QC 483-07 Terzi Properties
Site Plan MSP#05-07-08-0004-C
Eastern Shore, LLC

**RE: 05-07-08-0004-C; 313 Saddler Road
Terzi Properties Eastern Shore, LLC**

**RE: RESUBMITTAL OF MINOR SITE PLAN FOR TERZI PROPERTIES
EASTERN SHORE, LLC, GRASONVILLE, MISP #05-07-08-0004-C, DMS
& ASSOCIATES JOB #2006063**

SHEET No. - 1																																								
CADD FILE - 06063-DA

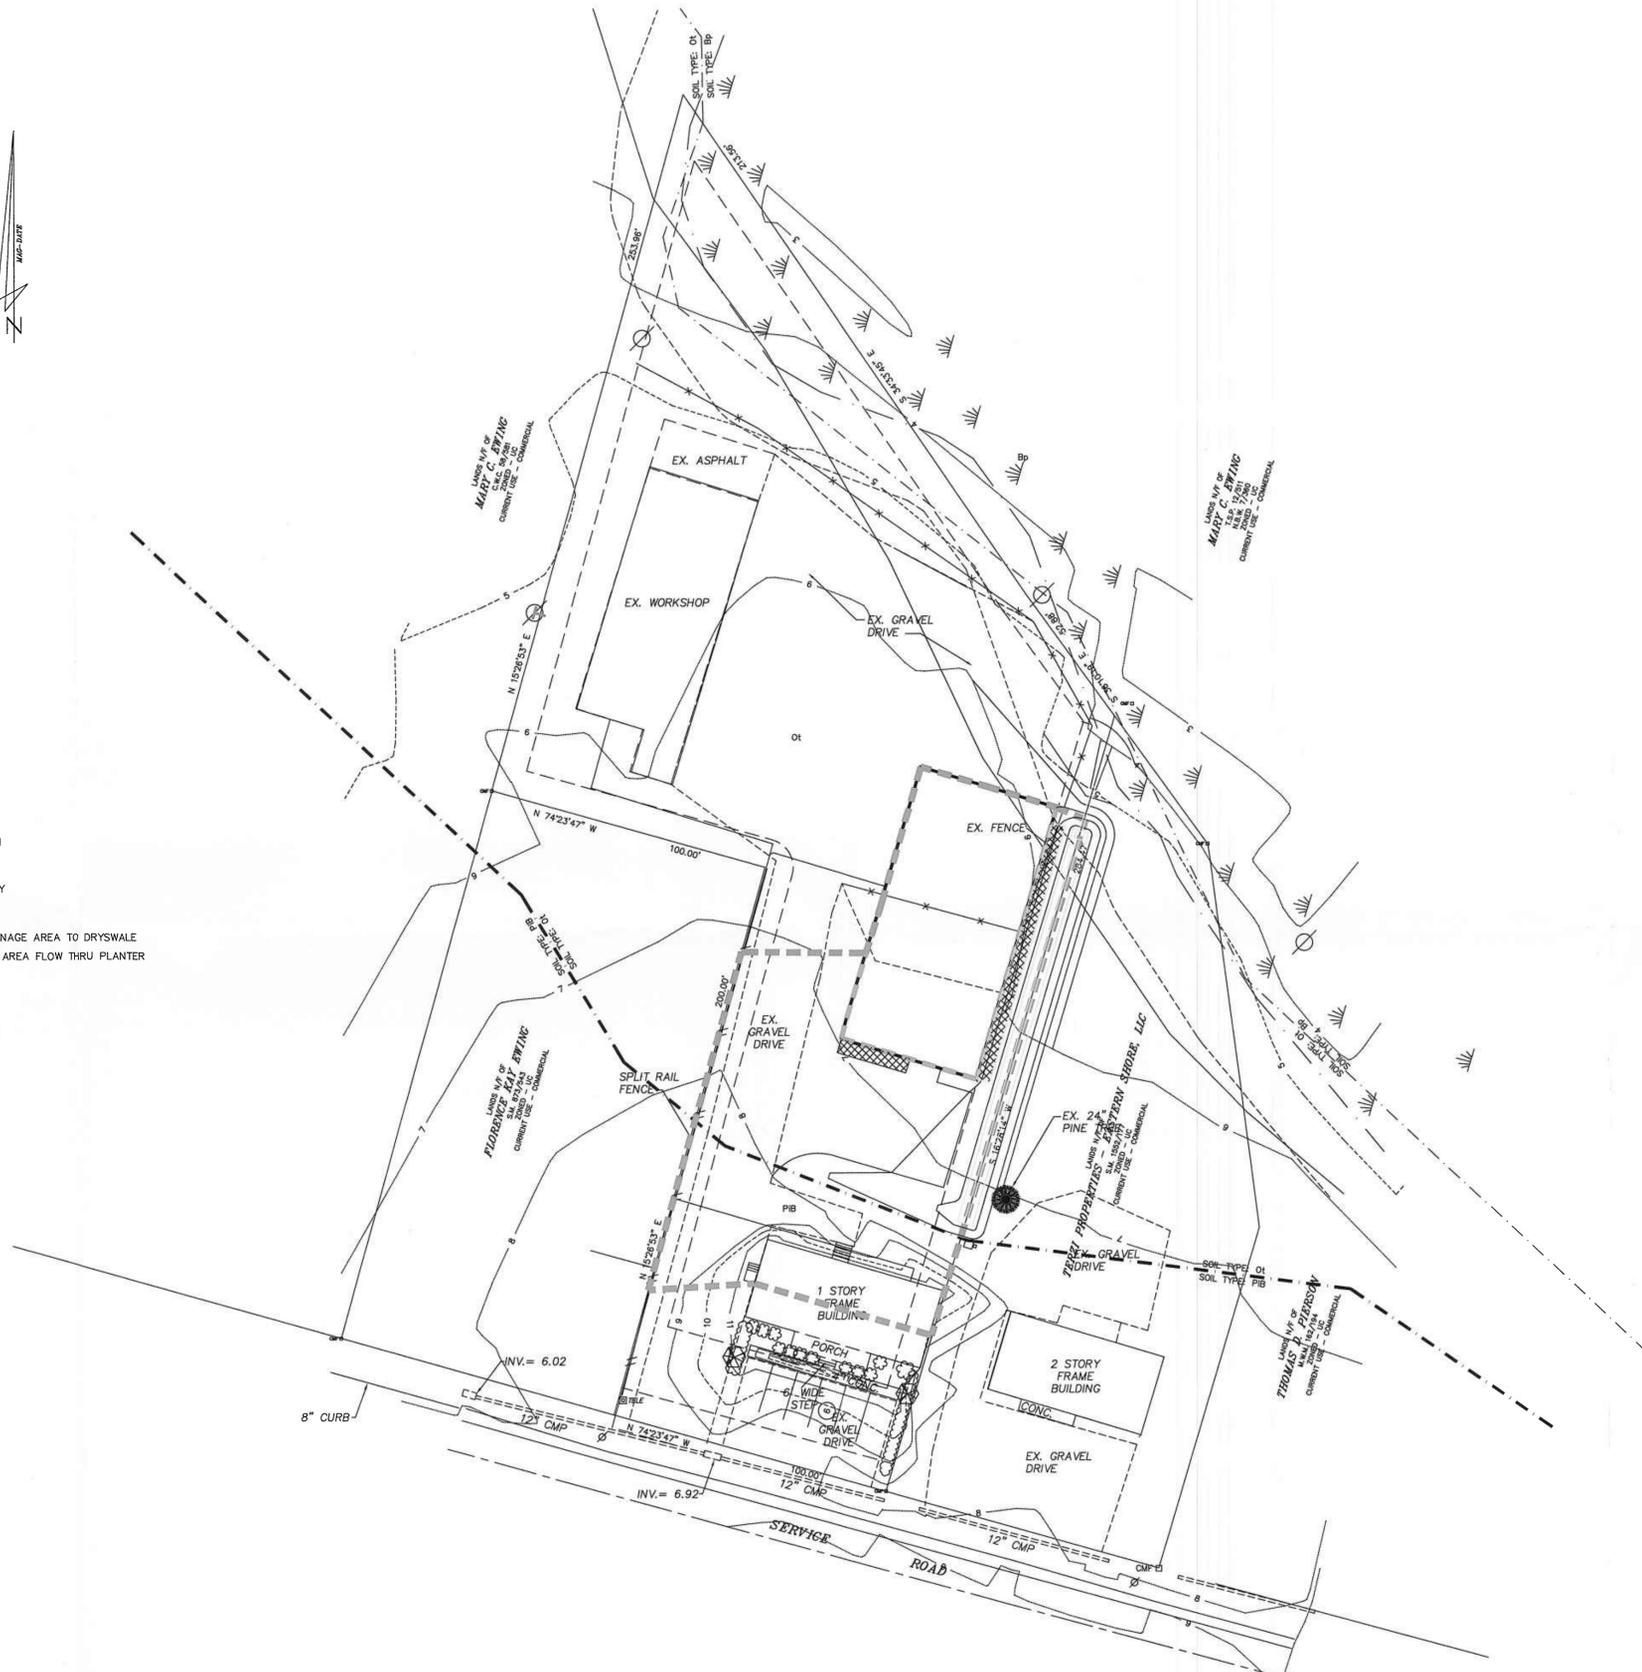
- b. Please provide this office with a copy of the drainage area maps for this project, including an outline of what areas of the site will drain into the proposed best management practices.

TOTAL SITE AREA:	= 1.26 AC.
EXISTING IMPERVIOUS AREA:	= 0.704 AC.
PROPOSED IMPERVIOUS AREA:	= 0.103 AC.
TOTAL IMPERVIOUS AREA:	= 0.807 AC.
TOTAL IMPERVIOUS AREA TO FLOW THRU PLANTER:	= 0.090 AC.
TOTAL IMPERVIOUS AREA TO DRYSWALE/BIOSWALE:	= 0.26 AC.
TOTAL DRAINAGE AREA TO DRYSWALE/BIOSWALE:	= 0.35 AC.

DATE	SCALE
JUNE '07	1" = 20'
JOB No. 2006063	DRAWN BY WJM/CGJ
FOLDER Ref. 58-2006063	DESIGNED BY WTD, Jr.
SHEET No. - C-03	
CADD FILE - 06063-C03

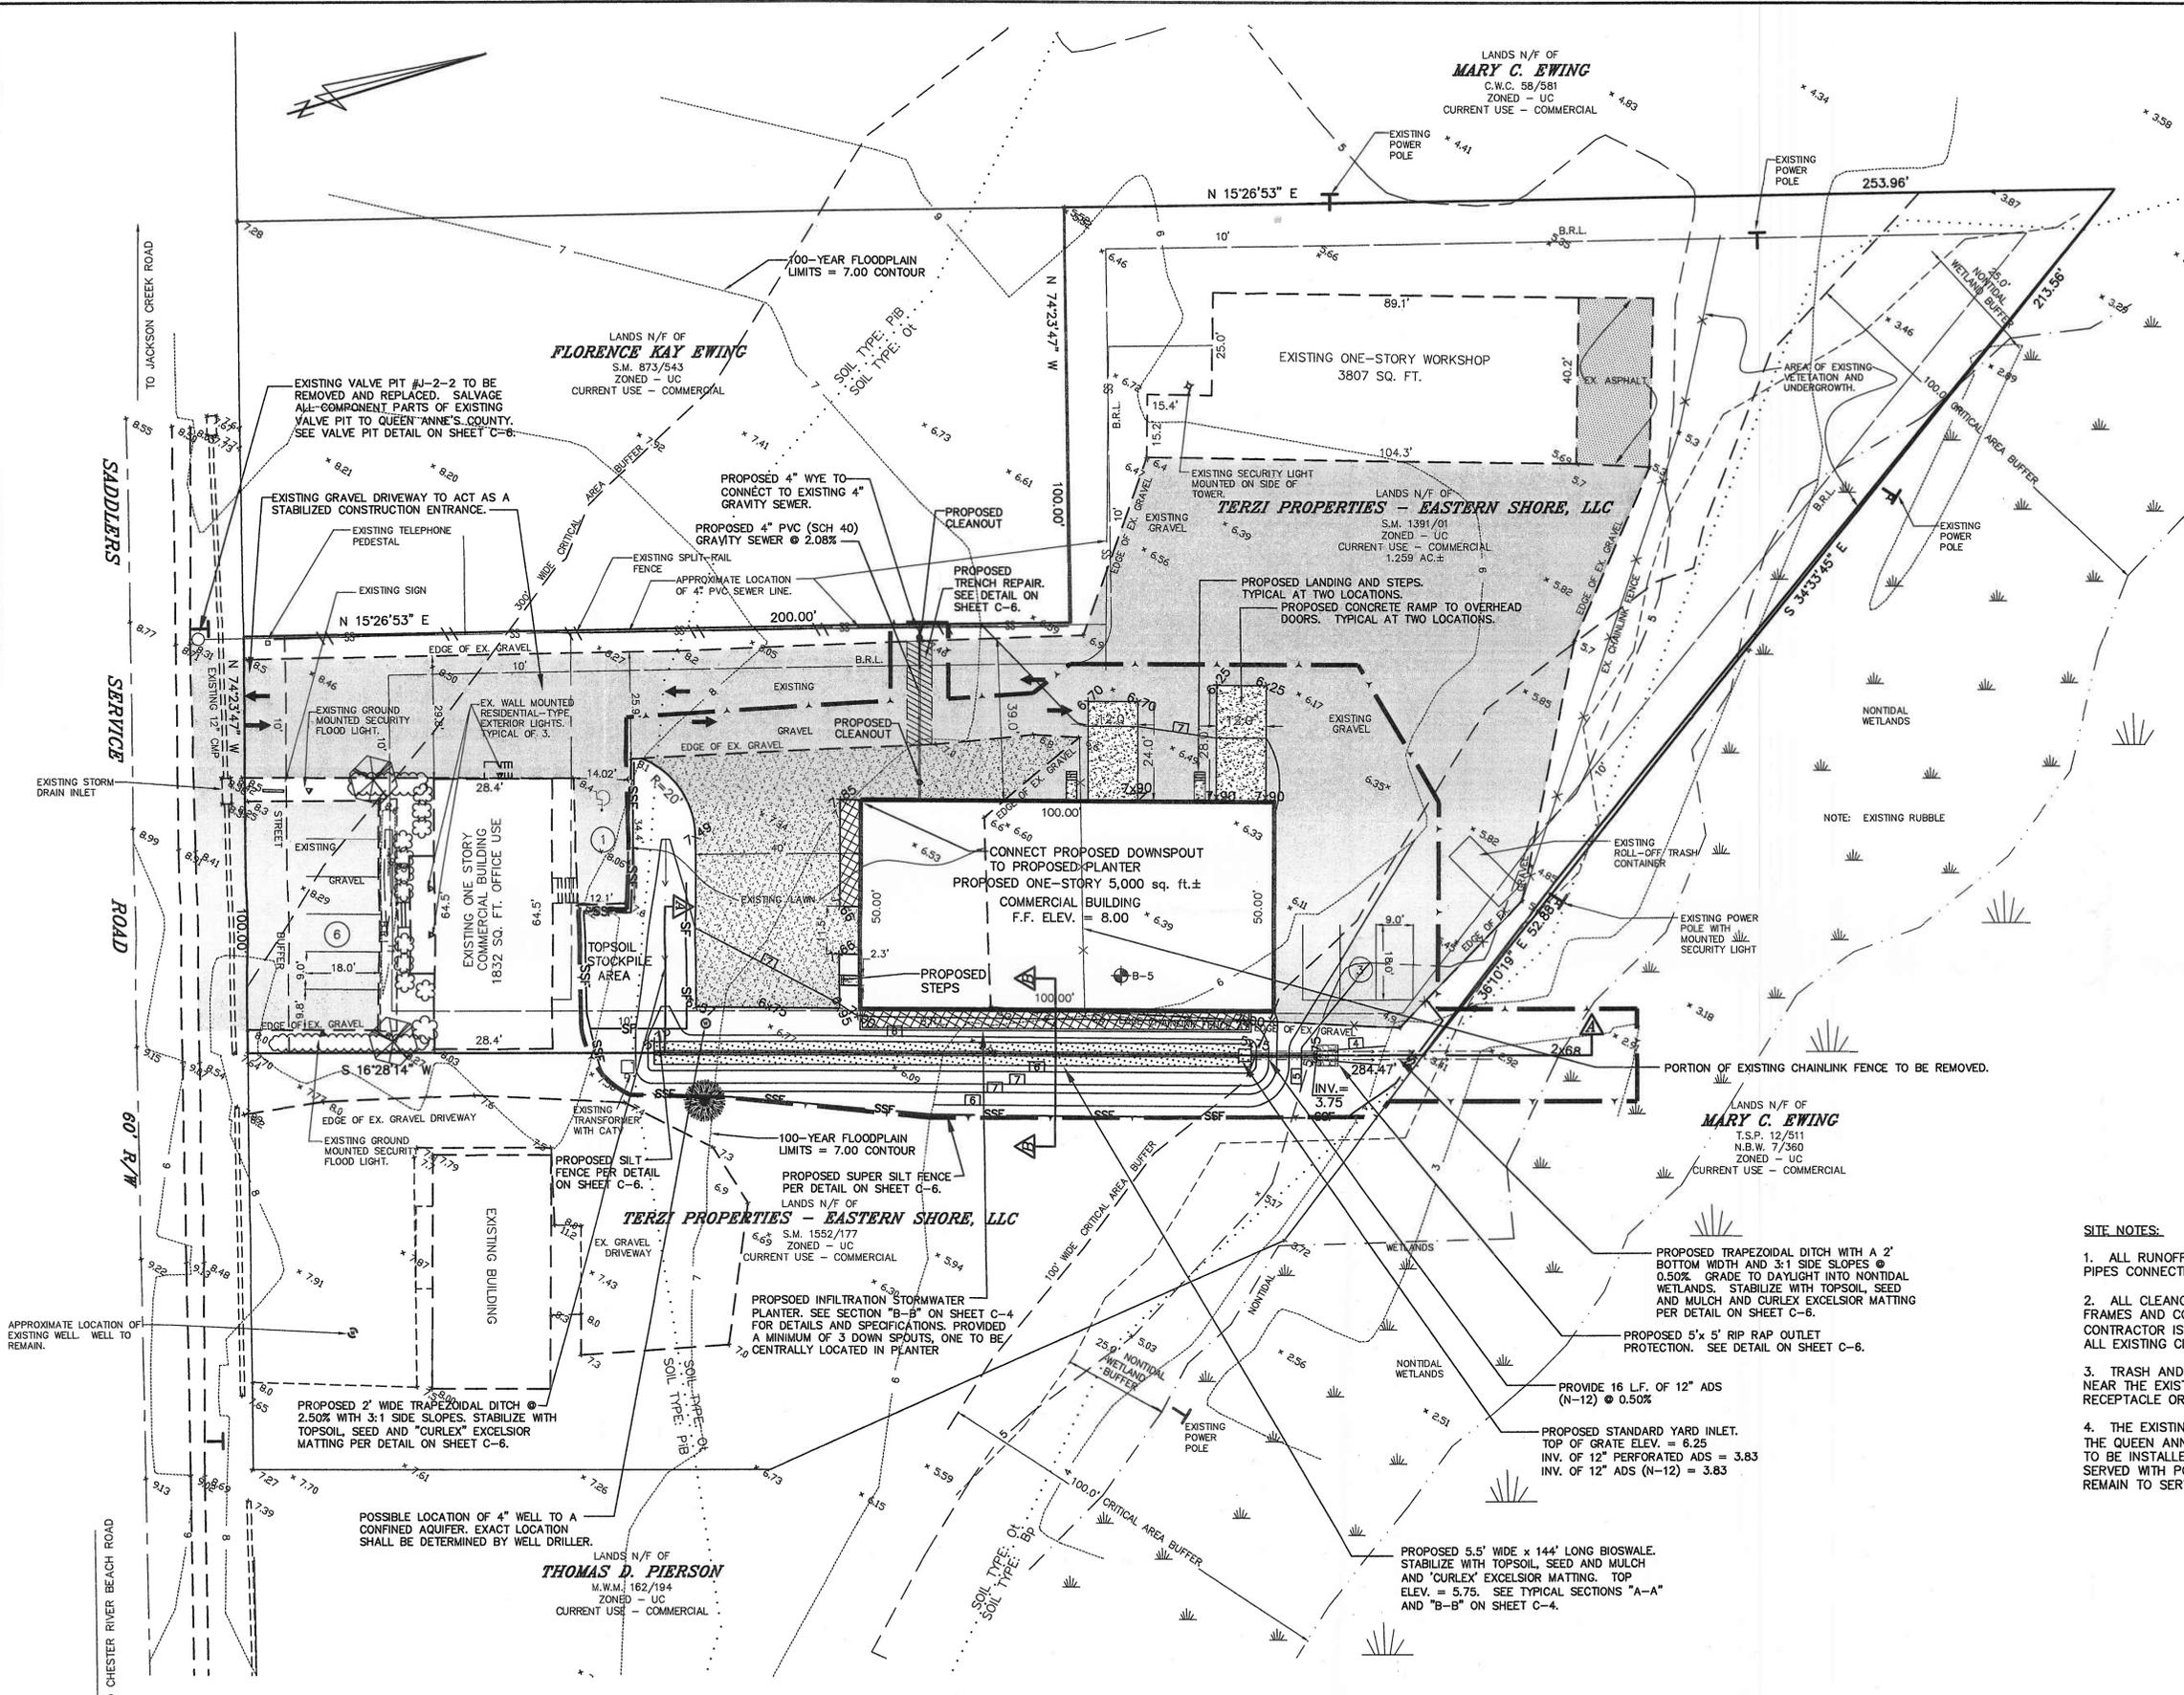
1. Any work for the outfall in the Critical Area Buffer must be shown as the limit of disturbance proposed in the Buffer. Since an outfall is a water dependant facility, no variance would be required, however, mitigation at a 1:1 ratio is required for the disturbance area. Please show the disturbance proposed, and the mitigation within the Buffer on site.
2. Please note that disturbance to the Buffer for grading for the sand filter is prohibited. See COMAR 27.01.09.01 and the Queen Anne's County Code §14:1-51.
3. The applicant is proposing handicapped plus two additional parking spaces within the 100-foot Critical Area Buffer, which would require a variance. County Code §14:1-51 (Buffer standards and requirements) states that new development activities, including erection of structures, parking areas or other impervious

4. The stormwater management plan states that the 10% reduction requirement is not met by the sand filter. Existing impervious gravel must be removed from the Buffer of this site to meet the 10% requirement before using the option of planting as an offset. Please have the applicant revise the plan and the stormwater management plan as such. (Critical Area 10% Rule Guidance Manual)

RUNOFF FROM THE SURFACE SAND FILTER IS TO DRAIN VIA THE TRAPEZOIDAL DITCH TO THE NONTIDAL AND TIDAL WETLANDS ADJACENT TO THE SITE. RUNOFF FROM EXISTING IMPERVIOUS SURFACES SHEET FLOW DIRECTLY TO THE NONTIDAL AND TIDAL WETLANDS ADJACENT TO THE SITE.

1. ALL RUNOFF FROM THE NEW BUILDING IS TO BE DIRECTED TO THE SURFACE SAND FILTER BY PIPES CONNECTED TO DOWNSPOUTS.
2. ALL CLEANOUTS (EXISTING AND PROPOSED) ARE TO BE PROVIDED WITH TRAFFIC BEARING FRAMES AND COVERS. CONTRACTOR IS TO COORDINATE WITH THE QUEEN ANNE'S COUNTY SANITARY DISTRICT TO UNCOVER ALL EXISTING CLEANOUTS AND PROVIDE THEM WITH TRAFFIC BEARING FRAMES AND COVERS.
